Work Order ID 99866

Item Name: Crosstube Aft

DRAWING NO. D407-667-245	TITLE CROSSTUBE ASSY (407 HIGH AFT)	REV. F	DART AEROSPACE LTD ENGINEERING ORDER		D.E.O. NO. D407-667-245-F-1	SHEET NO. SHEET 1 OF 2	SCALE NTS
DRAWN	CHECKED	MFG. APPR.	APPROVED		DE APPR.		
DATE 11.04.08	DATE 11.04.12	DATE 11.04.12	DATE 11.04.12		DATE 11.04.12

DRAWING NO. D407-667-245		TITLE CROSSTUBE ASSY (407 HIGH AFT)		REV. F		DART AEROSPACE LTD ENGINEERING ORDER		D.E.O. NO. D407-667-245-F-2		SHEET NO. SHEET 1 OF 1		SCALE NTS	
DRAWN <i>qp</i>		CHECKED <i>ASS</i>		MFG. APPR. <i>E</i>		APPROVED <i>MP</i>		DE APPR. <i>MP</i>					
DATE 11.09.07		DATE 11.09.19		DATE 11.09.19		DATE 11.09.19		DATE 11.09.19

DRAWING NO. D407-667-245	TITLE CROSSTUBE ASSY (407 HIGH AFT)	REV. F	DART AEROSPACE LTD ENGINEERING ORDER		D.E.O. NO. D407-667-245-F.1	SHEET NO. SHEET 2 OF 2	SCALE NTS
DRAWN	CHECKED	MFG. APPR.	APPROVED		DE APPR.		
DATE 11.04.08	DATE 11.04.11	DATE 11.04.12	DATE 11/04/12		DATE 11.04.12

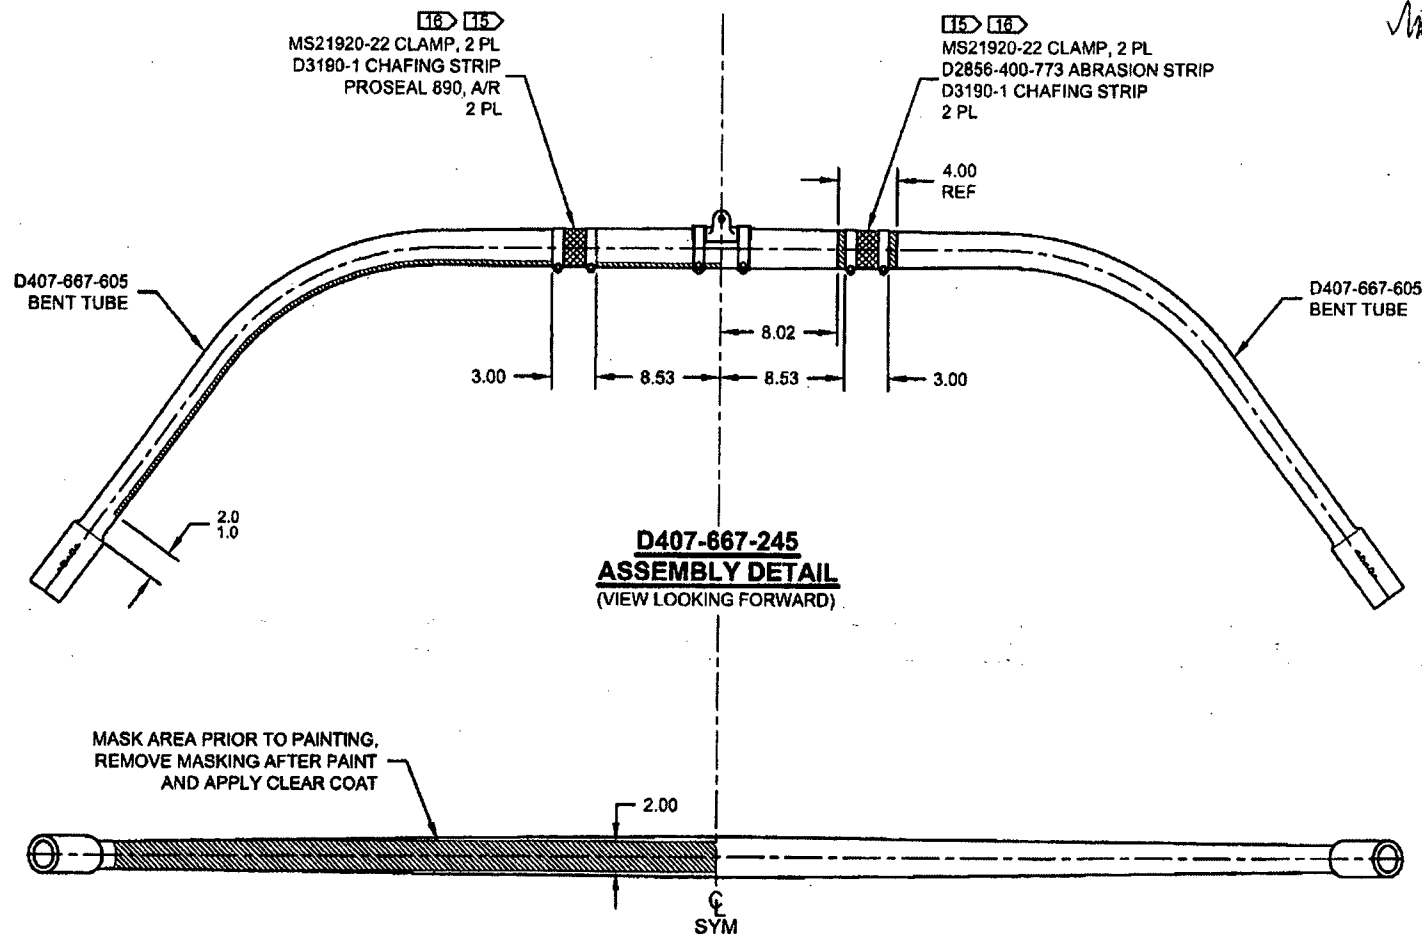
NOTES 2 AND 15, SHEET 1 ARE AMENDED AS FOLLOWS:

- 2) FINISH: CHEMICAL CONVERSION COAT PER DART QSI 005 4.1  
PRIME INSIDE AND OUTSIDE PER DART QSI 005 4.2  
MASK UNDERSIDE OF CROSSTUBE AS SHOWN (HATCHED AREA) AND  
PAINT OUTSIDE PER DART QSI 005 4.2  
REMOVE MASKING AND APPLY CLEAR COAT
- 15) APPLY A THIN COAT OF PROSEAL 890 ON INSIDE CONCAVE SURFACE OF D3190-1  
CHAFING SHIELDS AND LET CURE PER MANUFACTURER'S INSTRUCTIONS. INSTALL  
PROSEAL D3190-1 CHAFING SHIELDS ONTO CROSSTUBE BY APPLYING A THIN COAT  
OF PROSEAL 890 ONTO CROSSTUBE. BE SURE TO ELIMINATE ANY AIR GAPS.

- 2) FINISH: CHEMICAL CONVERSION COAT PER DART QSI 005 4.1  
PRIME INSIDE AND OUTSIDE PER DART QSI 005 4.2  
PAINT OUTSIDE PER DART QSI 005 4.2
- 15) INSTALL D2856-400-773 ABRASION STRIP WITH A 0.13 REF GAP ON BOTTOM SIDE OF  
CROSSTUBE PER QSI 035.
